Access Compliance Report

Public Rights-of-Way

(Curb Ramps)

Intersection ID: 46672	Main Street: DAMASK_DR	Cross Street: HUNSLET_CR	Location: NW
ADA ID: B1C6DA22A3D3	Ramp Type: Perp	Initial Pass/Fail: Fail	Overall Compliance: No
Severity Score: 8.75			
Codes/Mitigation Info/Possible Solution		Field Measurements/Component Compliance

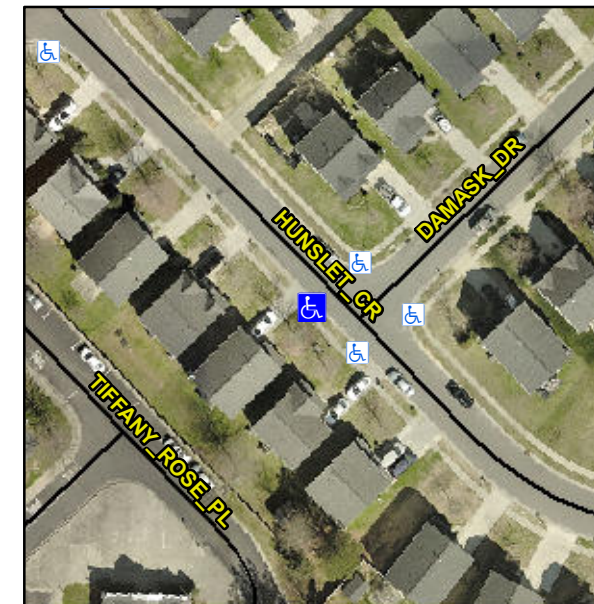
Not Found, R304.5.1

Compliance	Description	Data	Compliance	Description	Data
N/A	Ramp Length (in)	48.0	Yes	Ramp Slope (%)	6.9
No	Ramp Width (in)	46.0	Yes	Ramp XSlope (%)	2.0
N/A	Flare Type LT	N/A	N/A	Flare Type RT	N/A
N/A	Flare Slope LT (%)	N/A	N/A	Flare Slope RT (%)	N/A
N/A	Flare Traversable LT?	N/A	N/A	Flare Traversable RT?	N/A
N/A	Landing Length (in)	N/A	N/A	DWS Provided?	N/A
N/A	Landing Width (in)	N/A	N/A	DWS Contrast?	N/A
N/A	Landing Slope (%)	N/A	N/A	DWS Length (in)	N/A
N/A	Landing X Slope (%)	N/A	N/A	DWS Full Width?	N/A
N/A	Landing Curb? (Y/N)	N/A	N/A	DWS Offset (in)	N/A
N/A	Shared Landing?	N/A			
N/A	Gutter Ponding?	N/A	N/A	Gutter Slope (%)	N/A
N/A	Gutter Lip Ht (in)	N/A	N/A	Gutter X Slope (%)	N/A
N/A	Painted X Walk1?	No	N/A	Painted X Walk2?	N/A
	X Walk 1 Direction	To NE		X Walk 2 Direction	N/A
N/A	X Walk 1 Width (in)	N/A	N/A	X Walk 2 Width (in)	N/A
	X Walk 1 Slope (%)	3.8		X Walk 2 Slope (%)	N/A
	X Walk 1 X Slope (%)	2.6		X Walk 2 X Slope (%)	N/A

Remove & Replace Entire Ramp.
